Determination 2024/051

Compliance of roof cladding on a house with clause E2 External moisture

57A Bayview Road, Charteris Bay, Governors Bay

Figure 2: Eaves construction¹⁰ (not to scale)

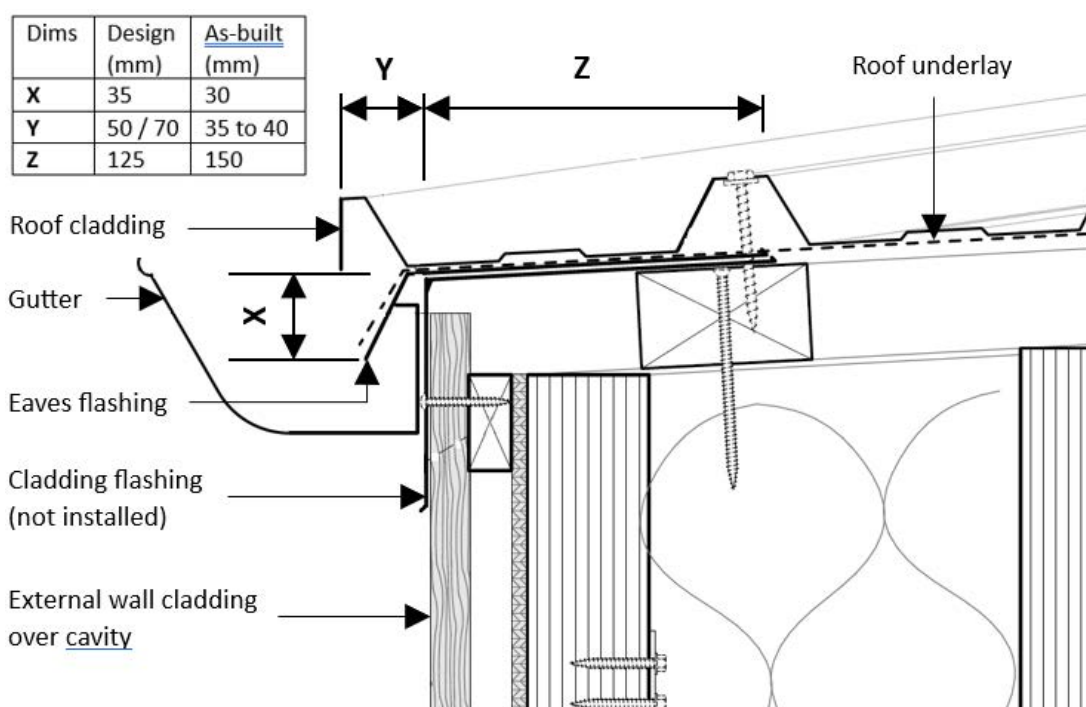
- 2.12. Several changes were made during the installation of the roof cladding system that departed from the building consent plans and specifications, including:
- 2.12.1. substituting an alternative lightweight trapezoidal (asymmetrical) proprietary metal roof cladding system
 - 2.12.2. substituting an alternative eaves flashing
 - 2.12.3. not installing the cladding flashing

- 2.12.4. not forming turn-downs at the lower ends of the roof cladding sheets
- 2.12.5. not installing foam closure strips.
- 2.13. On 18 February 2022, the authority carried out a final inspection of the building work. Regarding the roof cladding, the inspection record noted this passed, and the flashings had been sighted at an earlier 'pre-cladding inspection'. This may have been a reference to an inspection conducted on 18 May 2021, although the 'site notice' for that inspection does not mention the eaves or cladding flashings.

- (3) The roofing only has a minimal 35mm to 40mm overhang into the guttering.¹²
 - (4) The overlap of the eaves flashing into the gutter is only 30mm, possibly less, when Figure 45(a) in E2/AS1 and the manufacturer's plan indicates a minimum of 35mm is required.¹³

- (5) The cladding flashing shown in the building consent plans has not been installed.¹⁴
 - (6) The manufacturer's "specify that foam closures are used as required" but it is not clear whether they have been installed.

4.6. Some elements of the building work have not been completed in accordance with the building consent.²⁰ For example, the specified cladding flashing has not been installed, and the turn-downs to the edge of the roof sheets have not been formed.

- 4.10. The owners' roof cladding has a trapezoidal profile and a roof pitch of 5°, therefore, turn-downs at the gutter are required if constructed in accordance with Acceptable Solution E2/AS1. No turn-downs have been formed, and so the as-built building work does not comply with clause E2 by way of E2/AS1.

- 4.13.2. Contrary to the literature, the cladding does not have the turn-downs at the gutter.
- 4.13.3. The cladding only extends over the gutter by between 35mm and 40mm, in contrast to the manufacturer's stated minimum of 50mm.

- 4.13.4. The overlap to the gutter / fascia board is less than the manufacturer's minimum 35mm. (Refer paragraph 3.1.2(4).)
- 4.14. Based on the information provided by the owners, the as-built building work also does not fully comply with the NZMRM code of practice in the following respects (section reference numbers below are those applicable to the code of practice).

- 4.14.1. The eaves flashing has been installed but only extends 35mm to 40mm into the gutter, in contrast to the 50mm set out in section 5.3.5.4.
- 4.14.2. No profile closures have been installed, which according to section 5.7 should be used on all roof pitches below 10° when the wind design load is high or very high, and they should be compressed between the roofing sheets and supports or the flashing.

- 4.14.3. No turn-downs have been formed, though section 7.1.2 states all roof cladding with a pitch less than 8° must be provided with turn-downs.
- 4.14.4. The guttering only partially baffles the edge of roof cladding sheets, the roof pitch is 5°, and the sheets only overhang the gutter by between 35mm to 40mm. Section 7.1.4, states that where the ends of the cladding ribs are not baffled by guttering and the pitch is below 10°, the cladding overhang into the gutter should be increased to 70mm. In addition, in areas of very high wind load (which this dwelling is) additional methods (filler blocks, end-caps, over-flashings, baffles) are also required.

- 4.14.5. Section 8.4.1 states roof cladding must overhang the gutter by not less than 50mm, with a down-turned drip edge when the roof pitch is less than 8°, and a separate over flashing is recommended to be used. Although eaves flashings have been installed, the roof cladding sheets only overhang the gutter by between 35mm to 40mm, and no turn-downs have been formed at the edges.

- 4.18. The ability of the as-built roof cladding system as a whole to deflect water effectively is compromised by the minimal overhang of the roof cladding into the gutter, lack of turn-downs to the edge of the roof claddings sheets, and the minimal overlap of eave flashing. time.

- 4.23. The lack of turn-downs at the edge of the roof cladding sheets, the minimal overhang of the cladding into the gutter, the inadequate overlap of the eaves into the gutter flashing, and partial baffle of the roof cladding system by the gutter, means there will be an accumulation of salt-laden wind driven water and condensation to the underside of the cladding profile, leading to undue dampness in the roof assembly. I am of the view the roof cladding as installed will not be

4.24. Consequently, I conclude that the roof cladding system and associated flashings do not comply with clause E2.3.2.

5.1. In accordance with section 188 of the Building Act 2004, I determine the as-built roof cladding and associated flashings at 57a Bayview Road, Charteris Bay, do not comply with the Building Code Clause E2 *External Moisture*.
